# Review of Environmental Factors Addendum

## Cosgroves Creek Wastewater Network Stage 1 – SP1246 Services and Pipeline Alignment Changes

**Figure 1: Proposal change (1 of 3)**

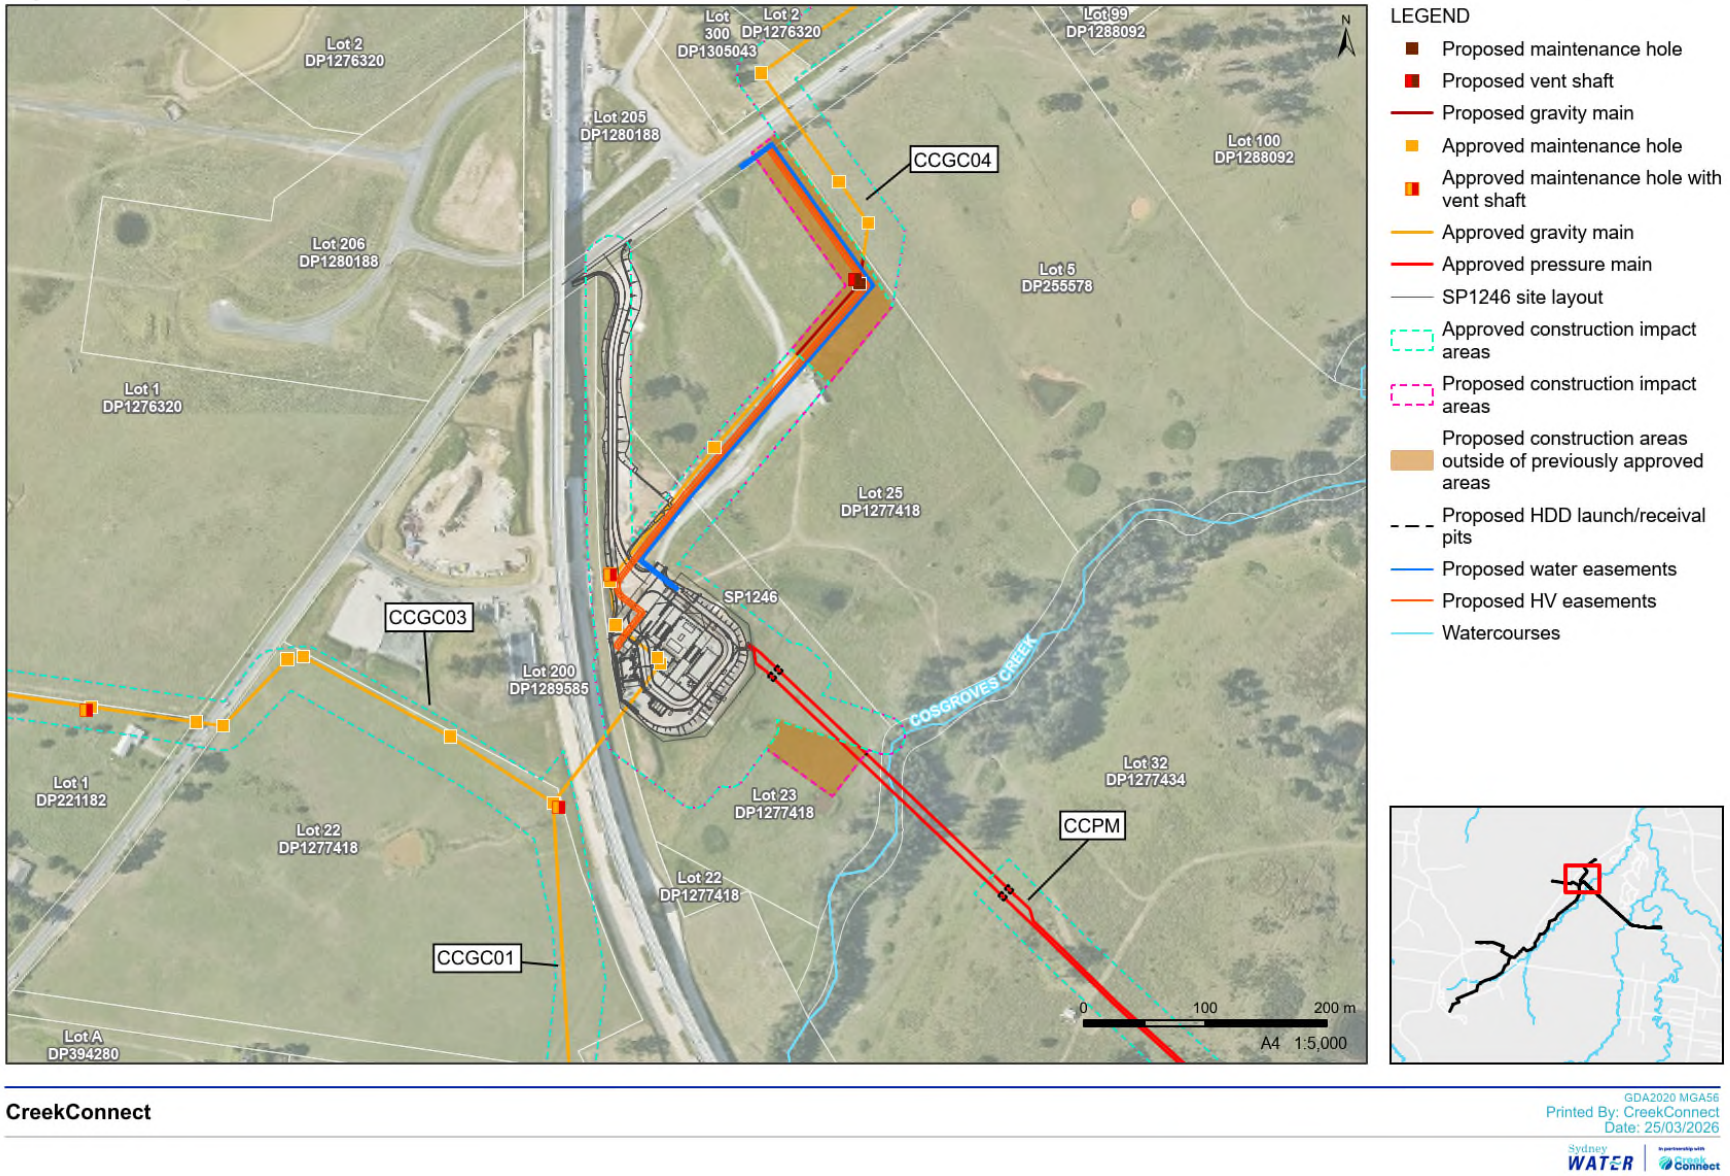
| Aspect | Relevance to proposal |
|---|---|
| Proposal change description and methodology | The proposal change involves construction of a services corridor to provide electricity and water services to SP1246 pumping station. It also includes modifying the Cosgroves Creek gravity carrier (CCGC01 and CCGC04) and Cosgroves Creek pressure main (CCPM) alignments, including the relocation of maintenance holes/pits along the alignments.<br><br>Specifically, the proposal change involves:<br>• Construction of a services corridor adjacent to the CCGC04 alignment within 546-640 Luddenham Road, from Luddenham Road to SP1246 to provide electricity and water to the pump station (refer to **Figure 1**)<br>• Modifying the gravity carrier alignments (CCGC01 and CCGC04), including the relocation and removal of maintenance holes along the alignment as below:<br>  ○ CCGC01: Shifted east through 812-844 Luddenham Road (refer to **Figure 3**)<br>  ○ CCGC04: Shifted northwest through 546-640 Luddenham Road (refer to **Figure 1**)<br>• Changing the CCPM alignment, including the relocation of the Horizontal Directional Drilling (HDD) launch/receival pits in two locations:<br>  ○ Shifted southwest at 546-640 Luddenham Road (refer to **Figure 1**) |

**Figure 2: Proposal change (2 of 3)**

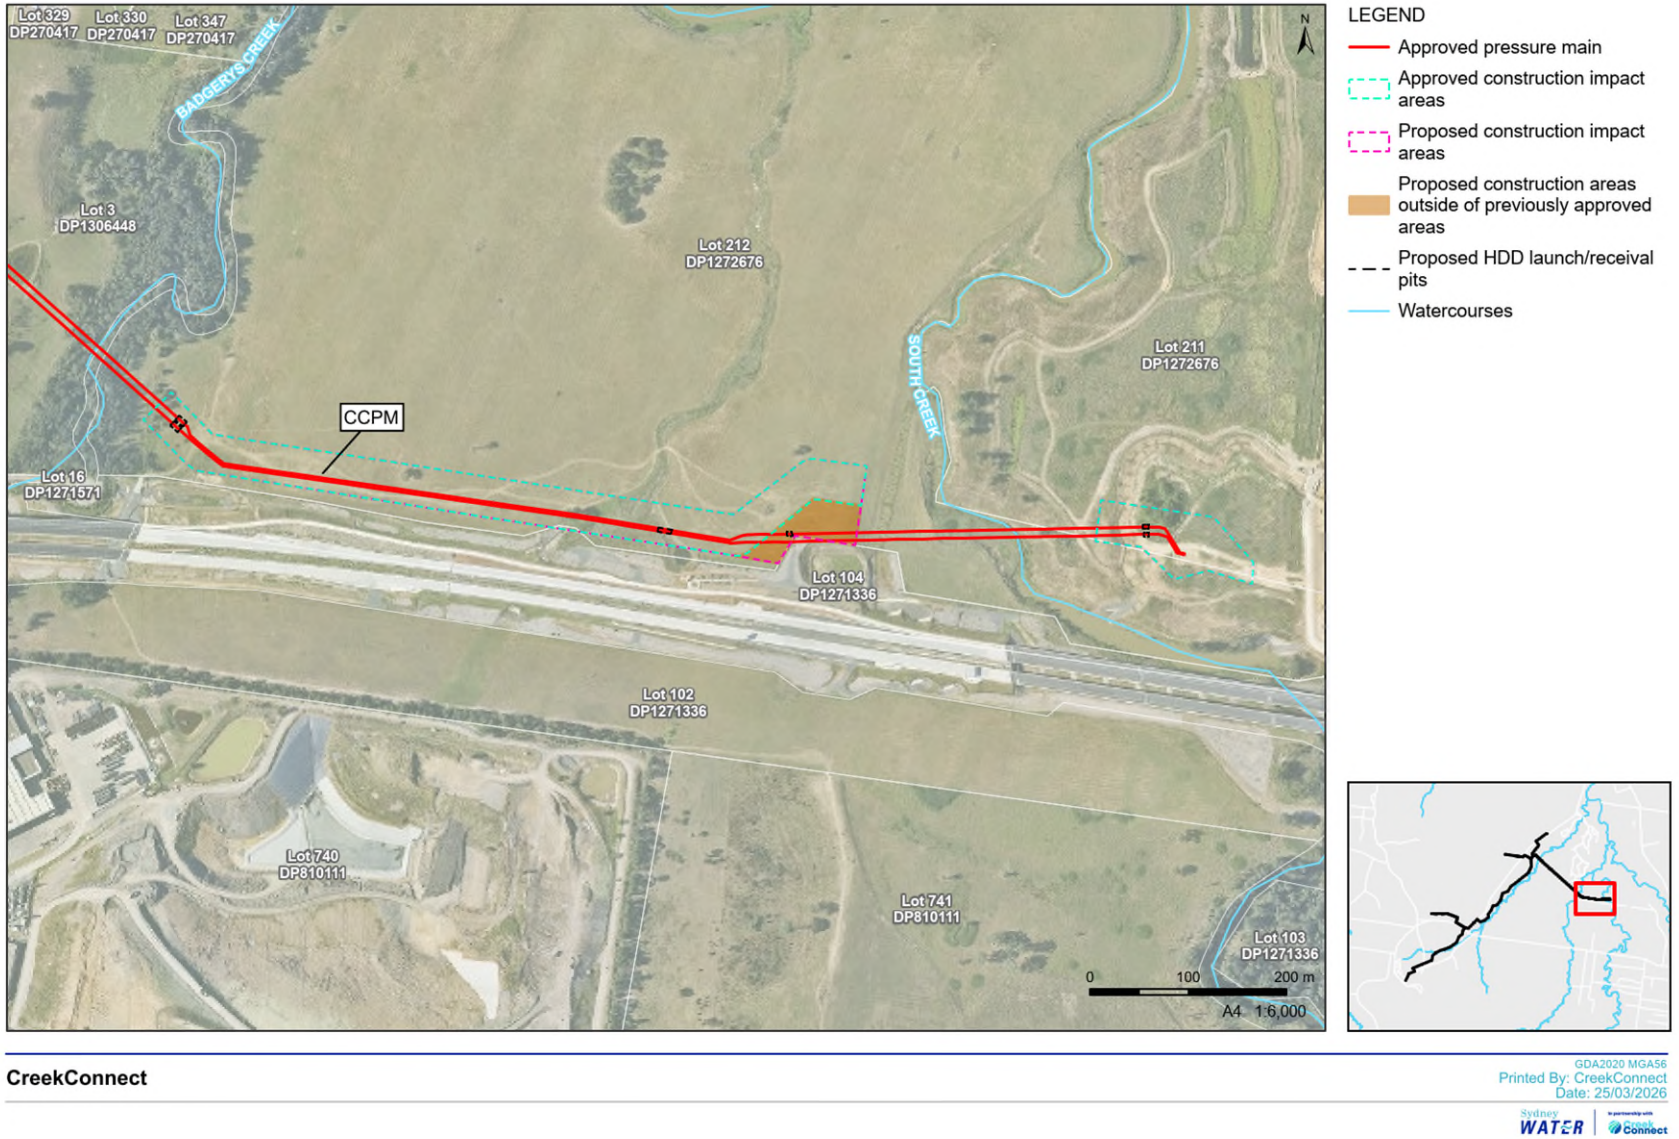
| Aspect | Relevance to proposal |
|---|---|
| | ○ Shifted south at 1793 Elizabeth Drive (refer to **Figure 2**)<br>The pipeline alignments will be constructed using a combination of open trenching and trenchless construction methods (e.g., HDD, Horizontal Auger Boring (HAB) and micro-tunnelling).<br>The alignment change for CCGC01 has removed the need for one maintenance hole and has reduced the length of gravity carrier by approximately 46m. |
